Change No. 15  
License No. DPR-28

SAFETY EVALUATION BY THE DIRECTORATE OF LICENSING

VERMONT YANKEE NUCLEAR POWER CORPORATION

CHANGE NO. 15 TO TECHNICAL SPECIFICATIONS

Figure 3.5.1.A Maximum Allowable Planar LHGR

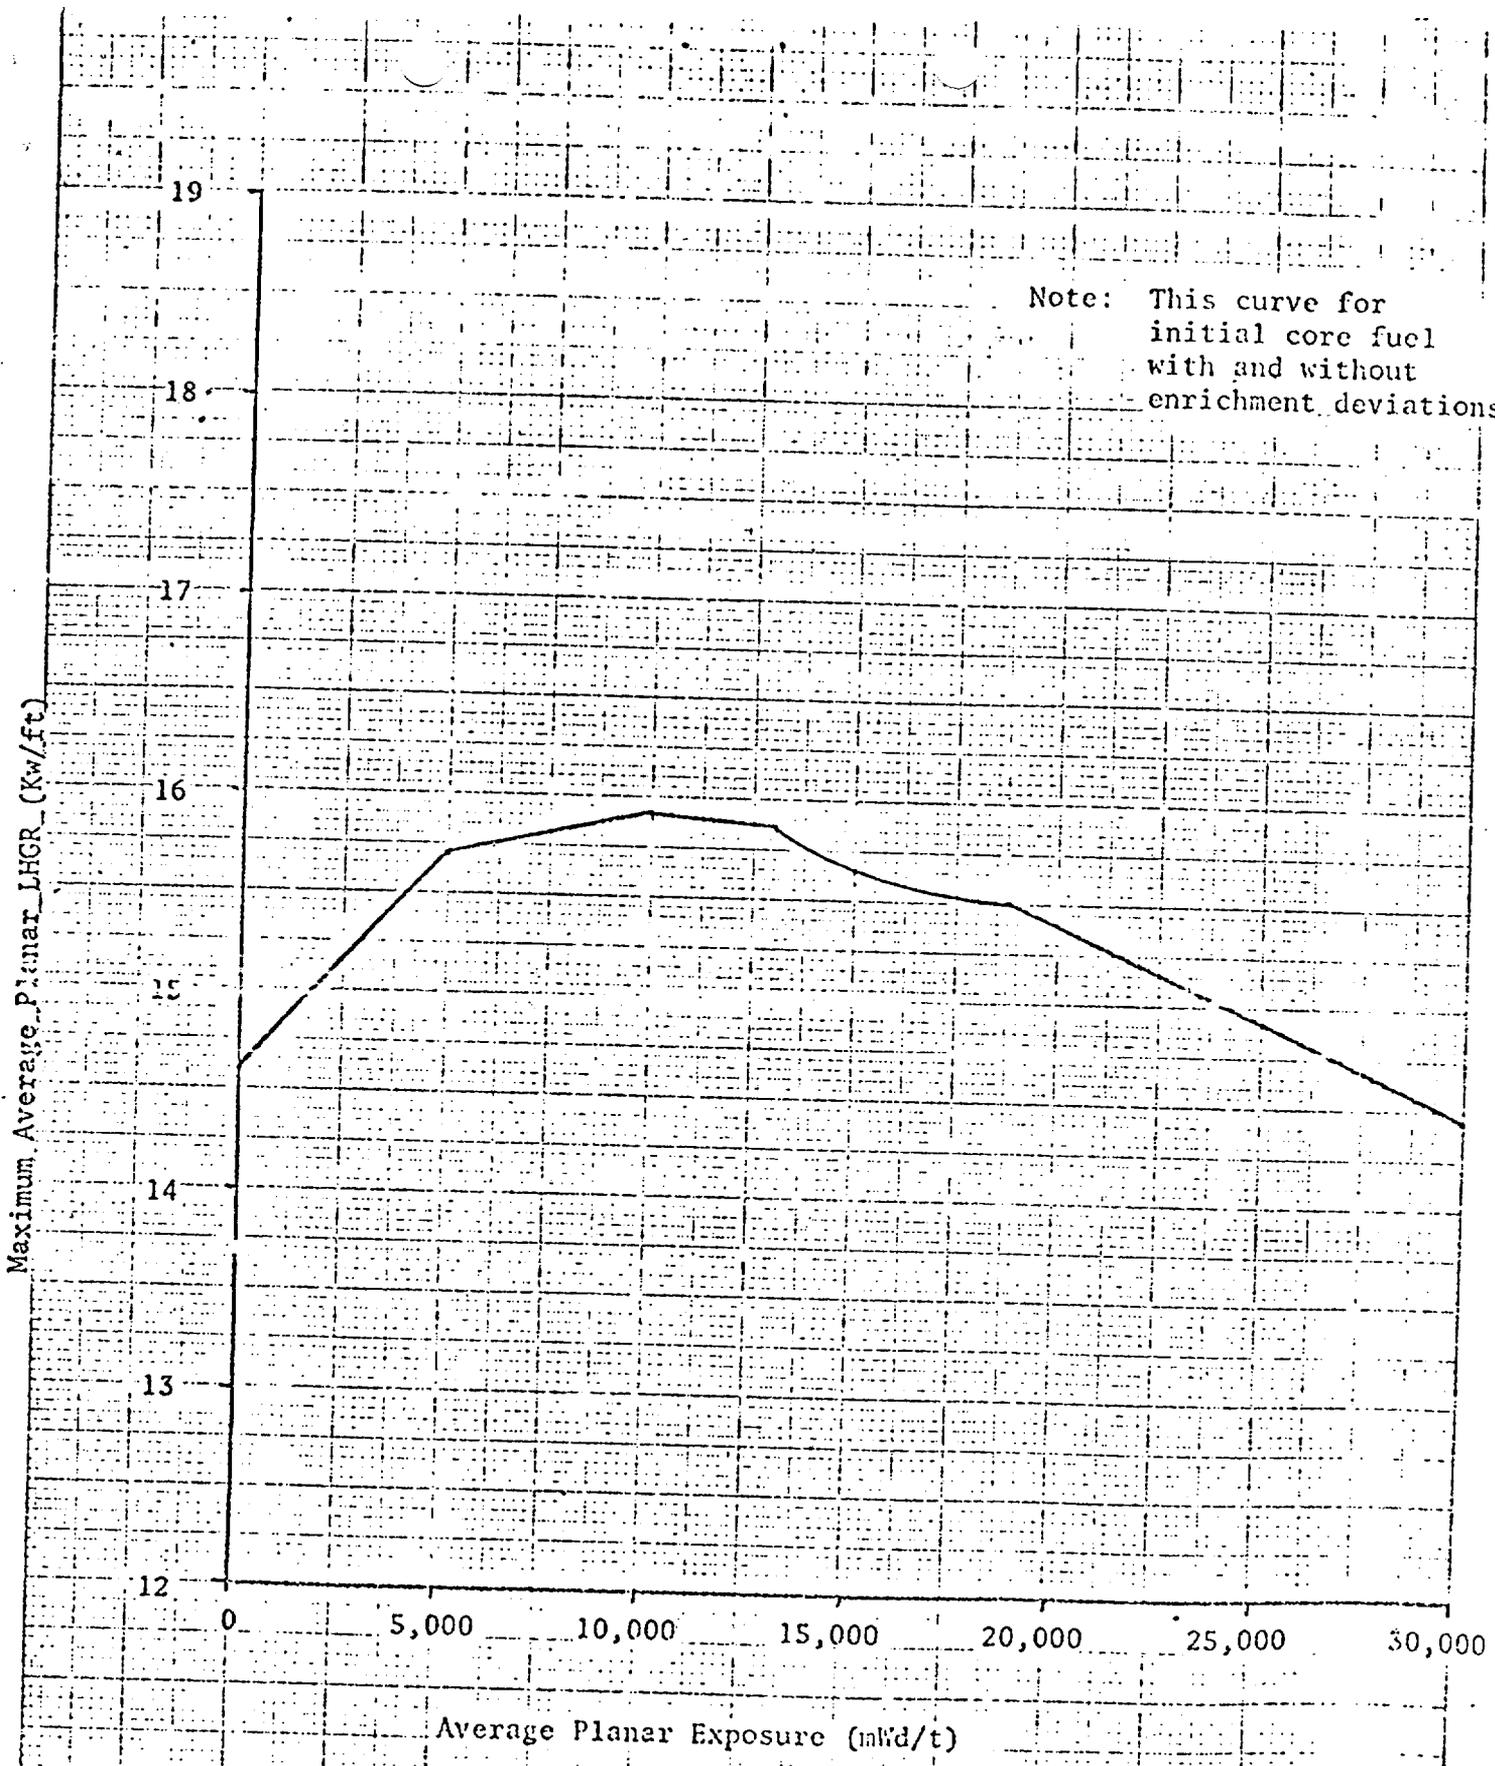
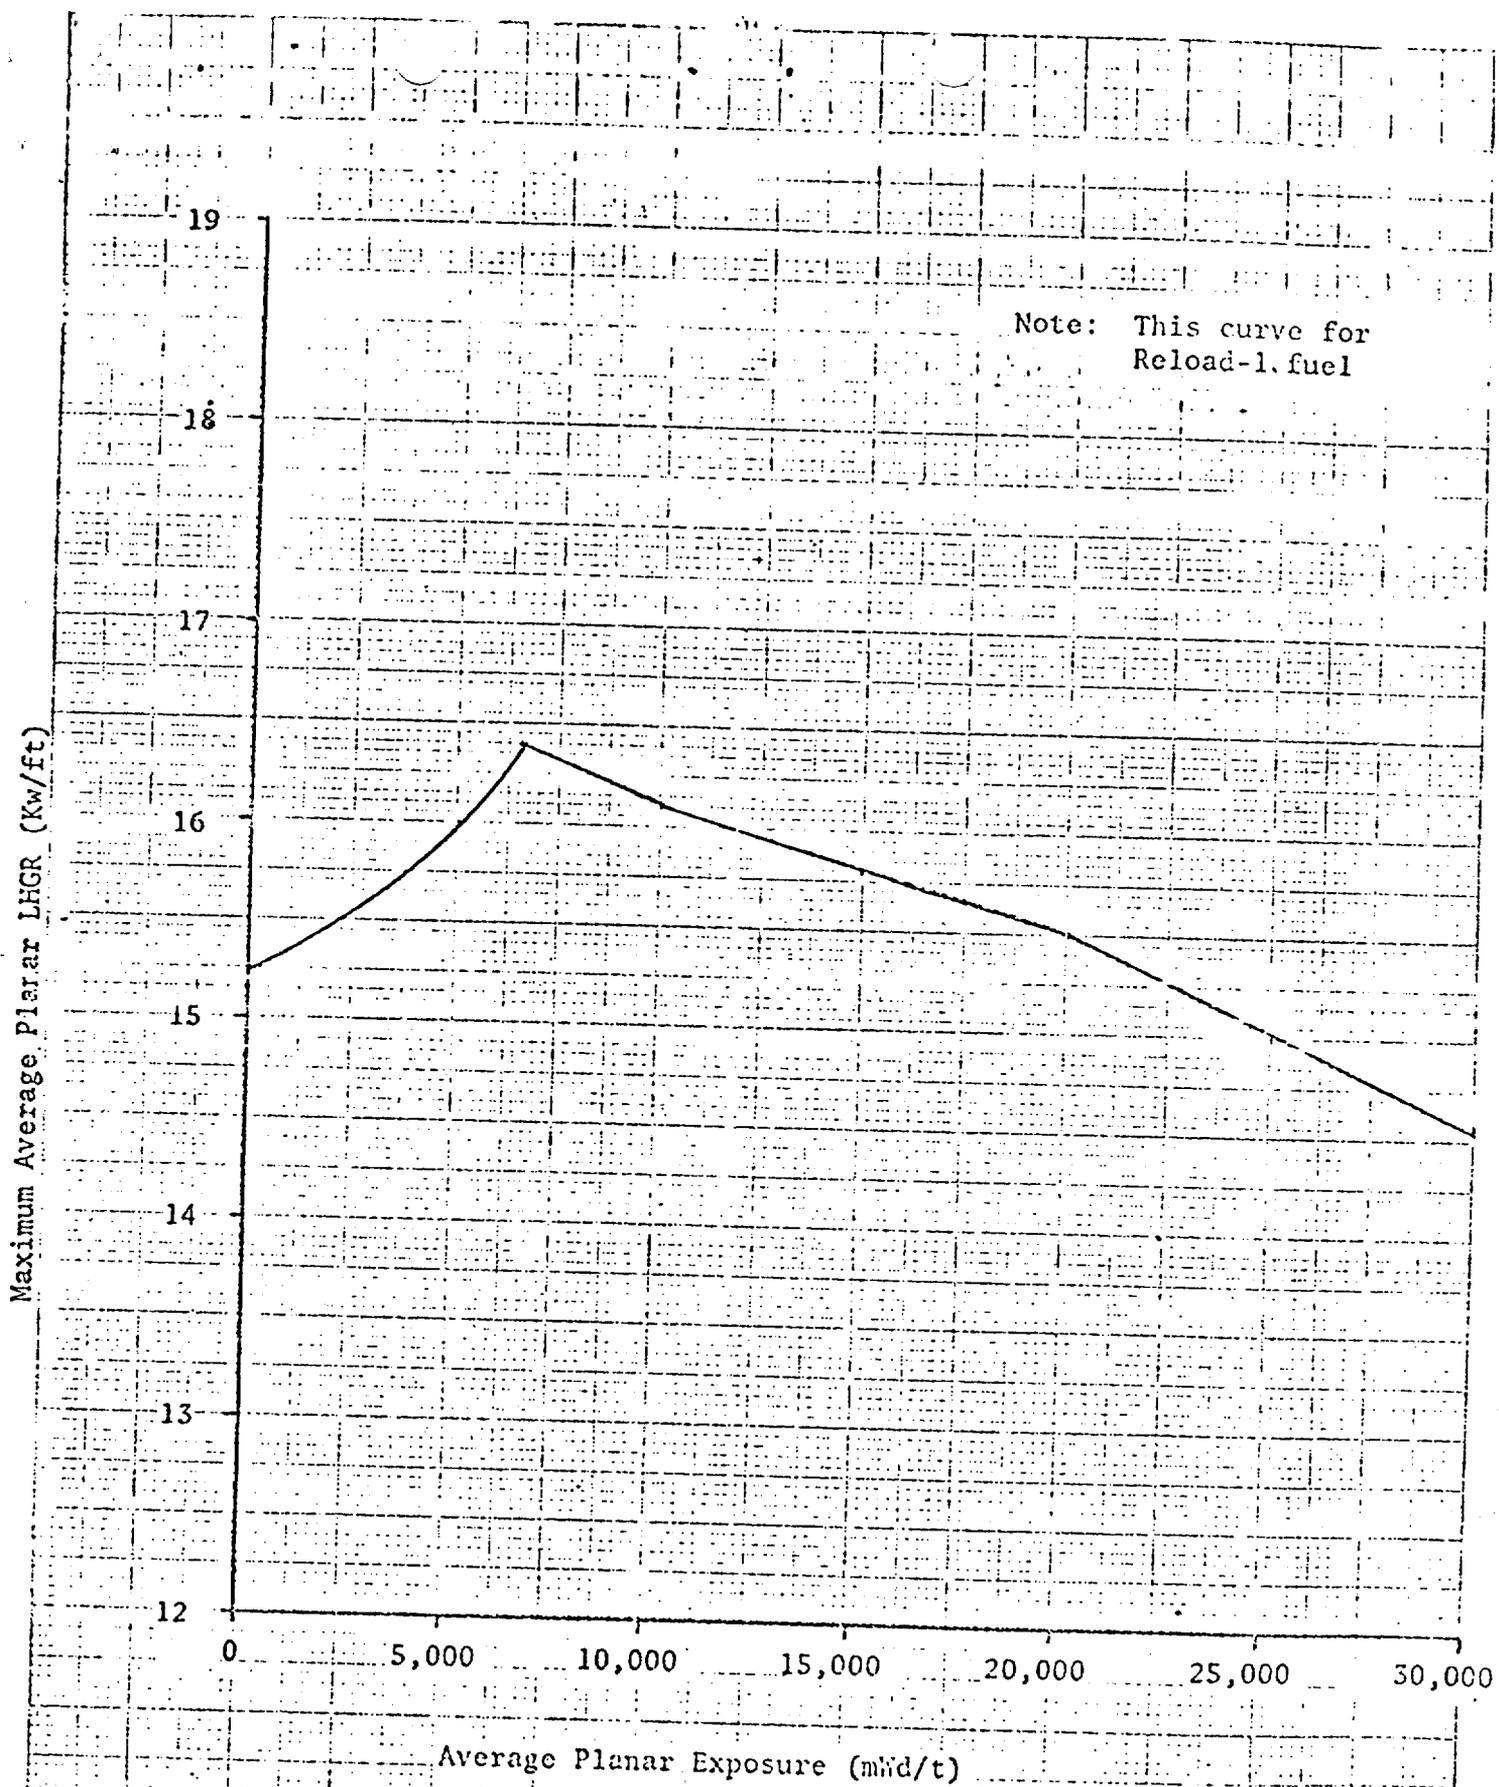
During steady state power operation, the average linear heat generation rate (LHGR) of all the rods in any fuel assembly, as a function of average planar exposure, at any axial location, shall not exceed the maximum average planar LHGR shown in Figure 3.5.1.

The maximum average planar LHGR shown in Figures 3.5.1.A and 3.5.1.B is the same as that shown on the curve labeled " $\Omega$ " (Omega) on Figures 1-G and 2-G in the General Electric letter of J. A. Hinds to V. A. Moore, "Plant Evaluations with GEGAP-III," dated December 12, 1973, based on calculations employing the models described in the General Electric reports NEDM-10735 as modified by the General Electric report NEDO-20181 and the aforementioned General Electric letter of December 12, 1973.

Figure 3.6.1 Minimum Reactor Pressurization Temperature

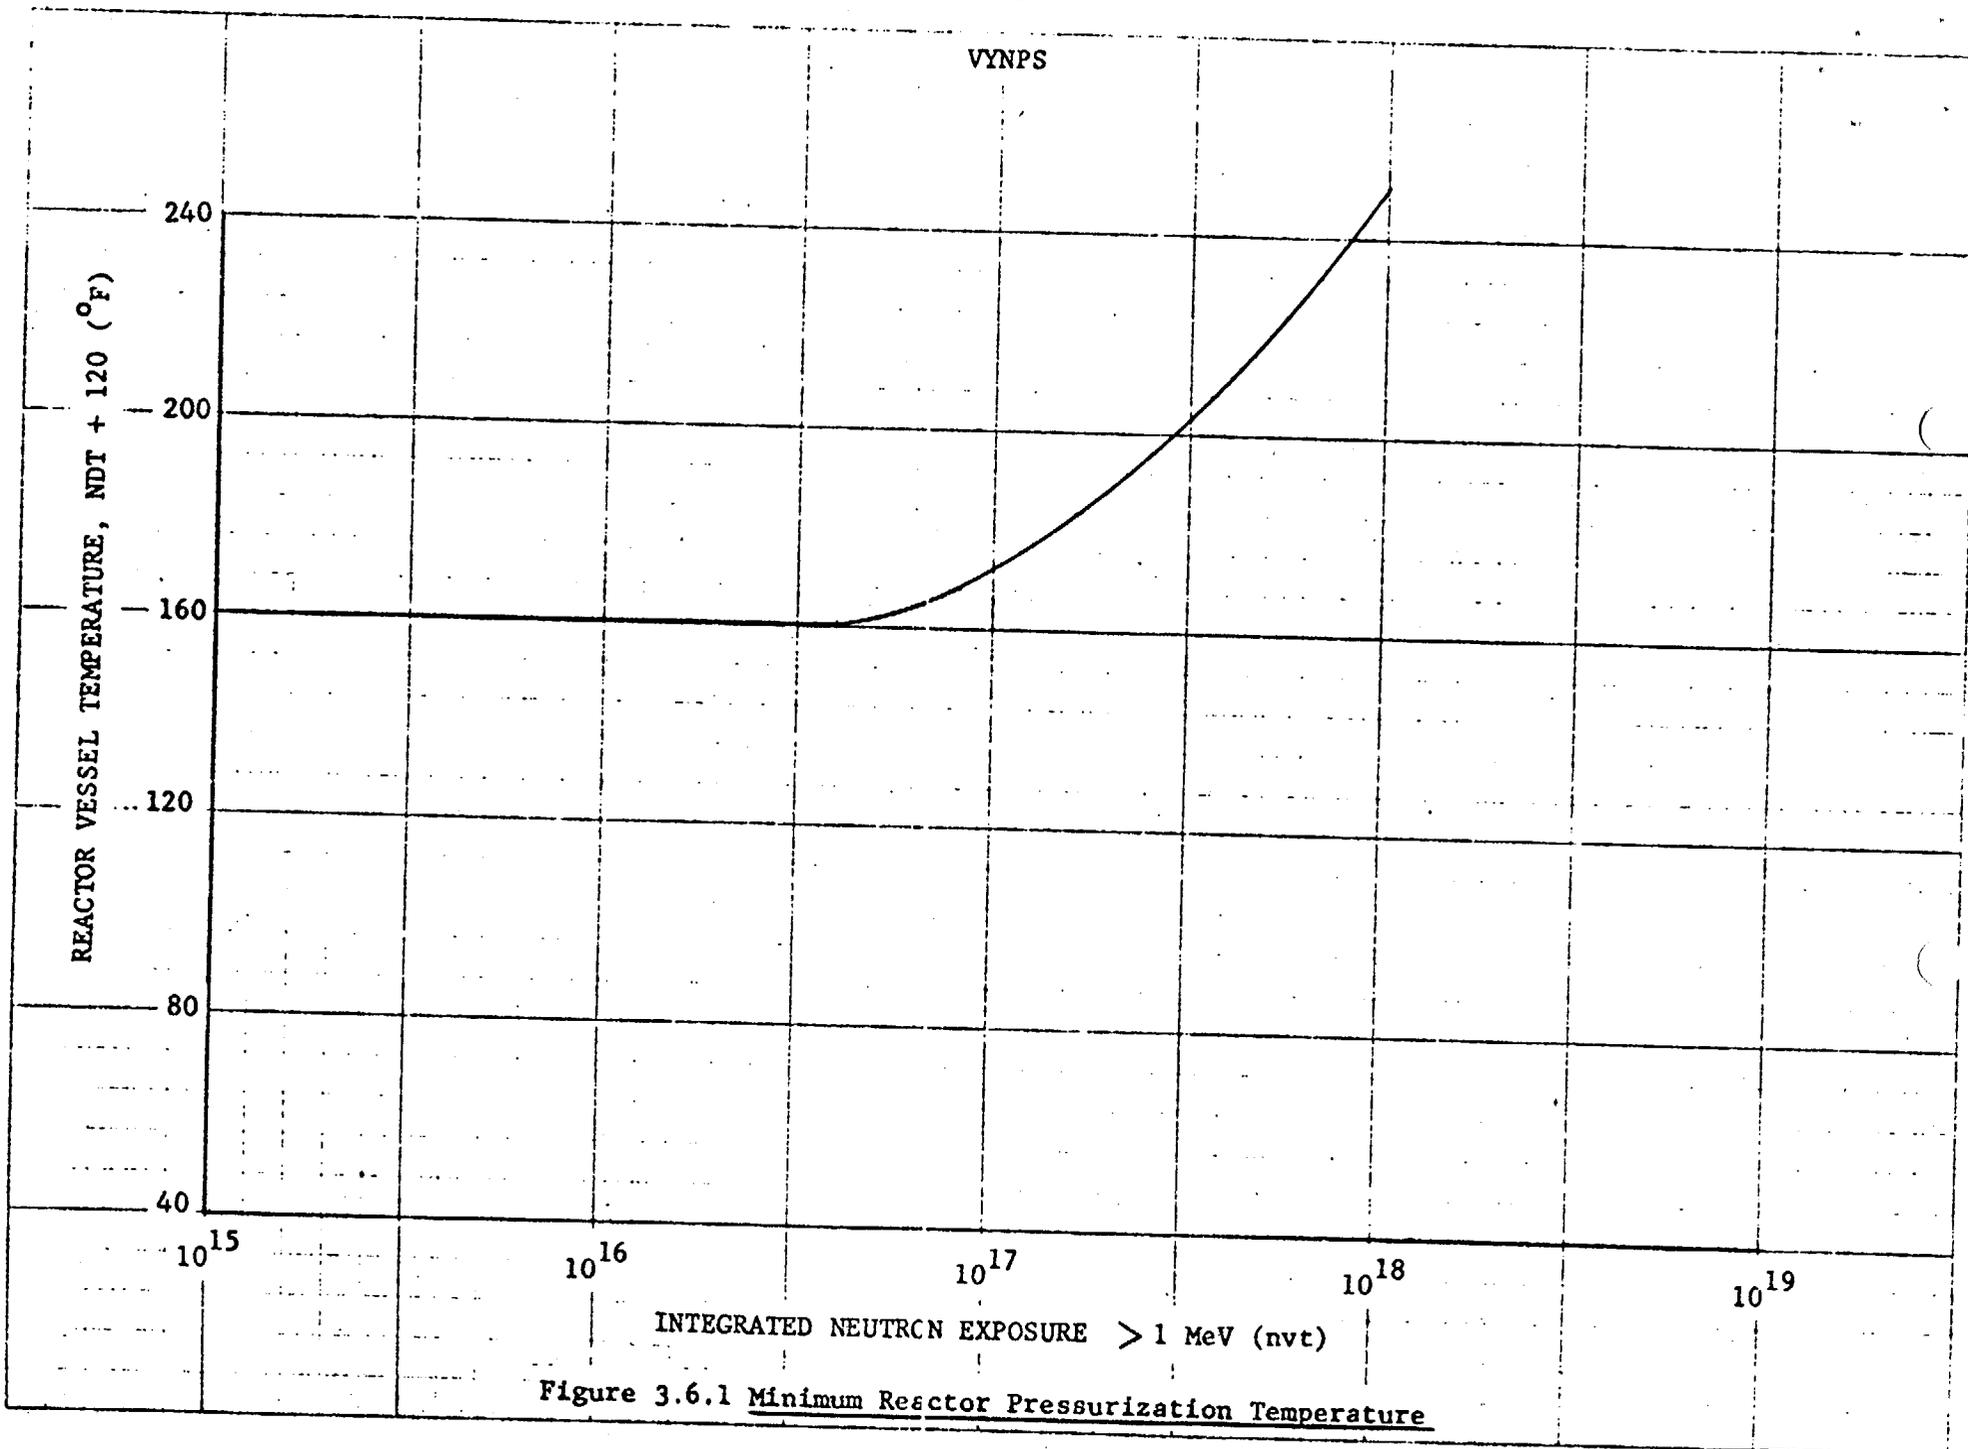
The "worst case" curve relating change in transition temperature to neutron fluence as presented in the FSAR was used to construct the "Minimum Reactor Pressurization Temperature" curve of Figure 3.6.1. This curve is based on an initial NDT of the vessel shell adjacent to the core. A 60°F margin based on the requirements of Section III of the ASME Boiler and Pressure Vessel Code, and a 60°F margin to account for the thickness effect of heavy section steel were added to 40°F to give the 160°F minimum temperature from initial operation to the time when the neutron fluence exceeds  $5 \times 10^{16}$  nvt. At that time the minimum temperature will increase steadily as the neutron fluence increases based on the "worst case" curve. After 40 years of operation the minimum operating temperature will be about 180°F.
